Board of Zoning and Planning Staff Report August 22nd, 2024

Matt Klingler, Zoning Officer

1) Application Number: BZAP-23-17

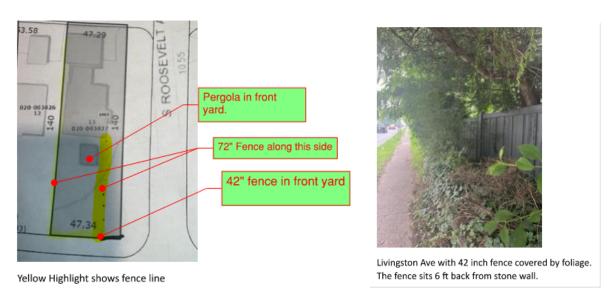
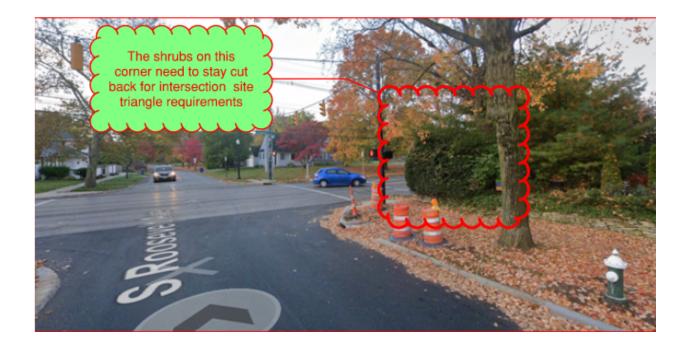
- R-6 Zoning District Corner lot Minimum dimensions 70' x 120' (8,400 sq. ft.)
 - This corner lot is a 47.29' x 140' deep (6,620.6 sq. ft.)
- The front yard is platted to Livingston, however front door faces Roosevelt.
- Per Bexley code section 1264.02 front yard fences between the height of 24" and 42" may be allowed via a special permit by the BZAP.
 - The east front yard fence is 72" tall.
 - The portion of the fence requires a variance
 - The west front yard fence (along Roosevelt) and the south front yard fence (along Livingston) is 42" tall.
 - This portion of the fence requires a special permit.
 - Per Bexley Code section 1252.15 (g) (1), accessory structures are only permitted in the rear yard.
 - This accessory structure, which looks to be a pergola/ covered deck and is located in the front yard of the property.

- The fences are heavily landscaped on the street side which is a requirement of the code.
- There is a retaining wall along to Roosevelt and Livingston Ave sidewalks which artificially raises the height above the maximum allowed 42" height for a special permit.
- As long as the trees and shrubs are trimmed back as far as possible (and kept that way) the site meets the "site triangle" requirements for corner lots.
- The house and garage sit at the far NW corner of the lot, so the house does not have much space for a rear private yard.
- The accessory structure is well hidden via trees and landscaping as is the fence.
